STAFF REVIEW AND RECOMMENDATIONS
PUBLIC HEARING
FEBRUARY 23, 2022

ABBREVIATED PLAT: LARKSPUR ADDITION 2021
LEGAL DESCRIPTION: SEC 34, T18N, R01E, SEWARD MERIDIAN AK
PETITIONERS: MATTHEW AND RUTH REISTERER
SURVEYOR/ENGINEER: FARMER SURVEYING / HOLLER ENGINEERING
ACRES: 13.73 ± PARCELS: 2
REVIEWED BY: MATTHEW GODDARD CASE #: 2022-009

STAFF REVIEW AND RECOMMENDATIONS
PUBLIC HEARING
FEBRUARY 23, 2022

ABBREVIATED PLAT: WEE BIT O' THE WORLD
LEGAL DESCRIPTION: SEC 34, T18N, R02W, SEWARD MERIDIAN AK
PETITIONERS: ELVIRA MURRI
SURVEYOR/ENGINEER: FARMER SURVEYING/WALDEN CCE, LLC
ACRES: 5 ± PARCELS: 3
REVIEWED BY: AMY OTTO-BUCHANAN CASE #: 2022-010

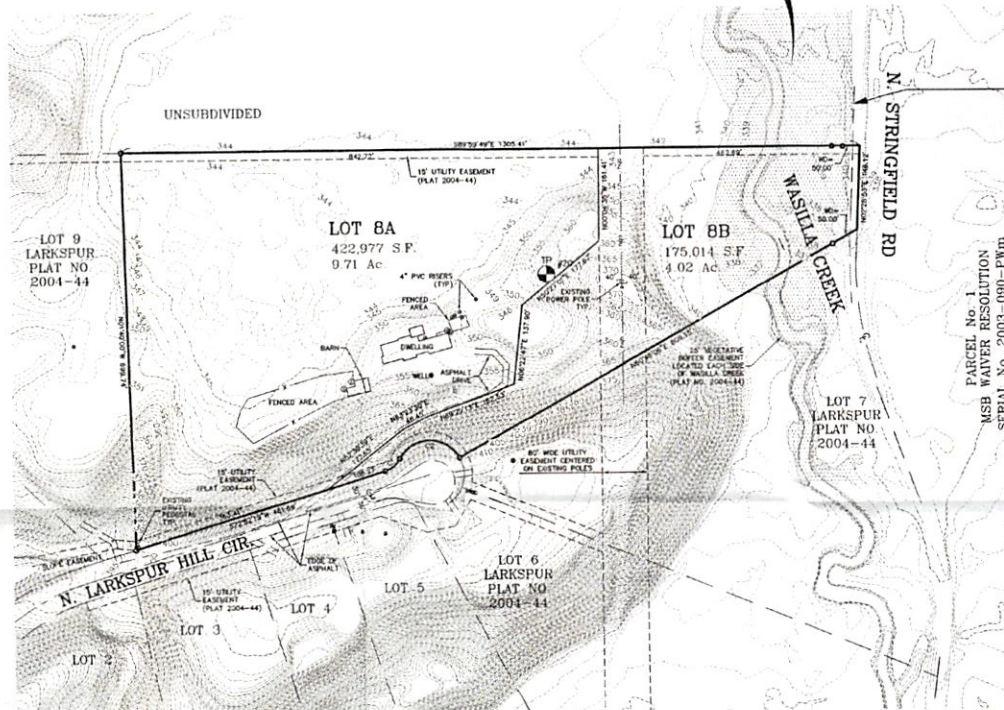
Utilities: (Exhibit E) Enstar notes that there is an existing natural gas service line which appears to cross proposed Lot 8B to serve proposed Lot 8A. Enstar objects to this plat unless one of the following scenarios is met:

1. Add a note which says “There is a ten foot wide natural gas easement centered on the existing service line” and draw in the approximate location of the service line on the map and add, ”Approximate location of natural gas service line and centerline of ten foot (10 ft) wide natural gas easement”.
2. Owner signs an Enstar Natural Gas Easement document for a ten foot (10 ft.) wide natural gas easement centered on the service line at this location.

ENSTAR Natural Gas Company has reviewed preliminary plat **LARKSPUR 2021 ADDITION (MSB Case # 2022-009)** and advises that there is an existing natural gas service line which appears to cross proposed Lot 8B to serve proposed Lot 8A. Attached is an approximate ENSTAR as-built for you reference. ENSTAR objects to this plat unless one of the following scenarios is met:

1. Add a note which says, "There is a ten foot (10 FT) wide natural gas easement centered on the existing service line." And draw in the approximate location of the service line on the map and add, "Approximate location of natural gas service line and centerline of ten foot (10 FT) wide natural gas easement".
2. Owner signs an ENSTAR Natural Gas Easement document for a ten foot (10 FT) wide natural gas easement centered on the service line at this location.

Staff notes that an abbreviated plat cannot grant easements. If the petitioner so chooses, they may grant the requested easement by document and recorded information will be shown on the final plat. (See Recommendation #4)

W.O. 2100155 DATE: JAN., 2022
 DRAWN BY: JMC SCALE: 1" = 50'
 FILE: 2100155_PL SHEET 1 OF 1

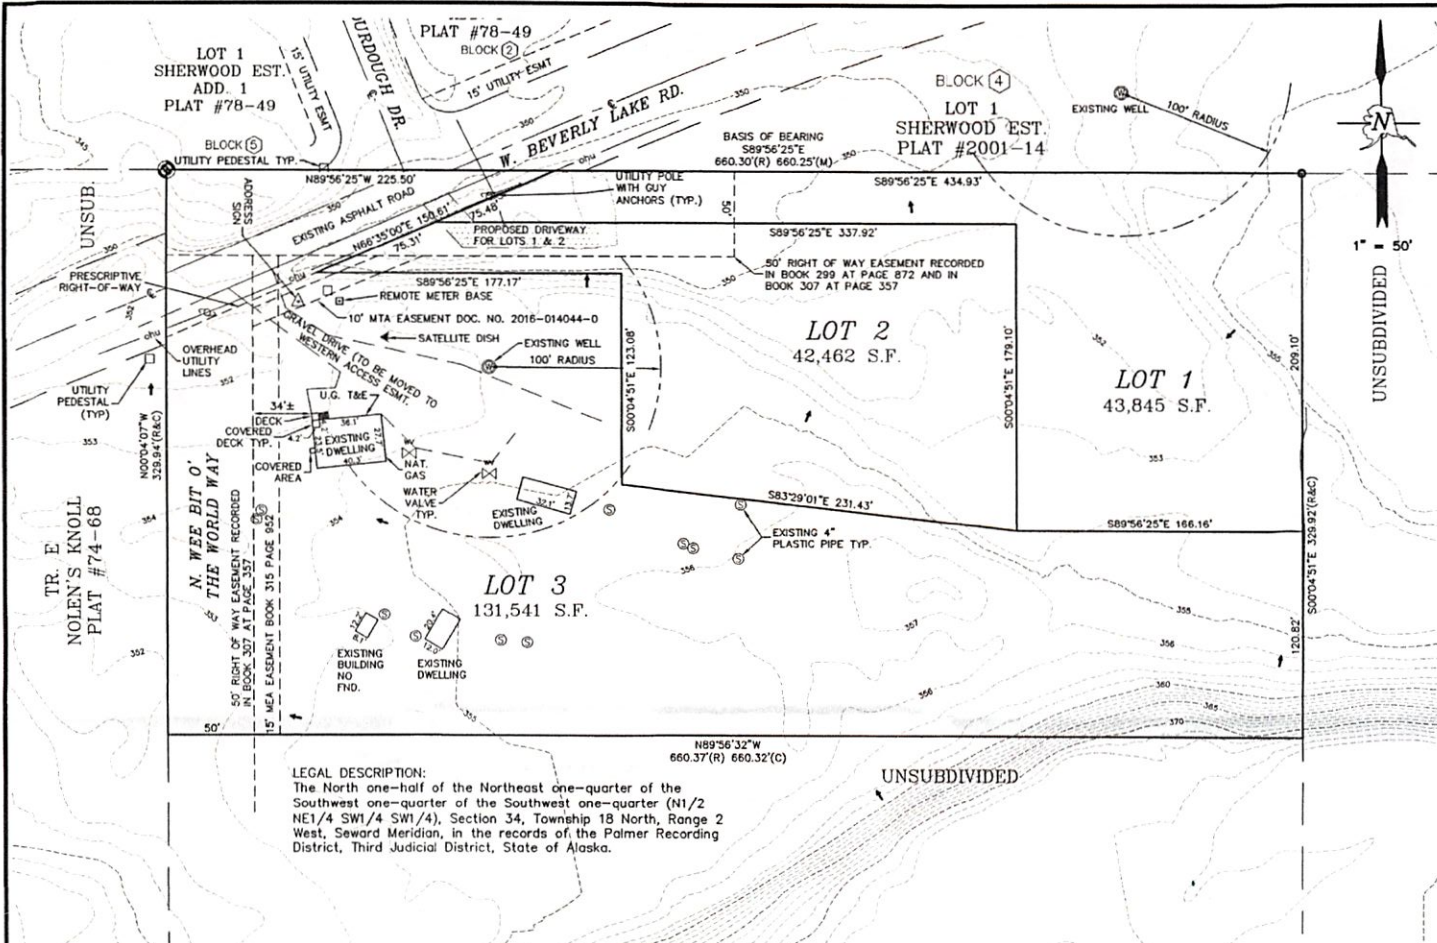
Road Service Area #27: (**Exhibit G**) Stephen Edwards notes “Lot 1 appears difficult to access with construction manual compliant driveway due to power pole and guy wires. Lots 1 and 2 are too small to be good home sites. Another mess certain to cause well and septic conflicts in the future.”

Amy,
It may seem obvious but the access to lot 1 seems to be interrupted by a utility pole and I didn't see where it was being moved.

Yes, it will be conditions of approval – one to apply for a permit to work within the 50' wide right-of-way and another condition to provide proof the existing driveway has been removed. A condition of approval to add a plat note for the common lot line driveway for Lots 1 & 2 will be added. Let me know if you have any further comments. Thanks, A.
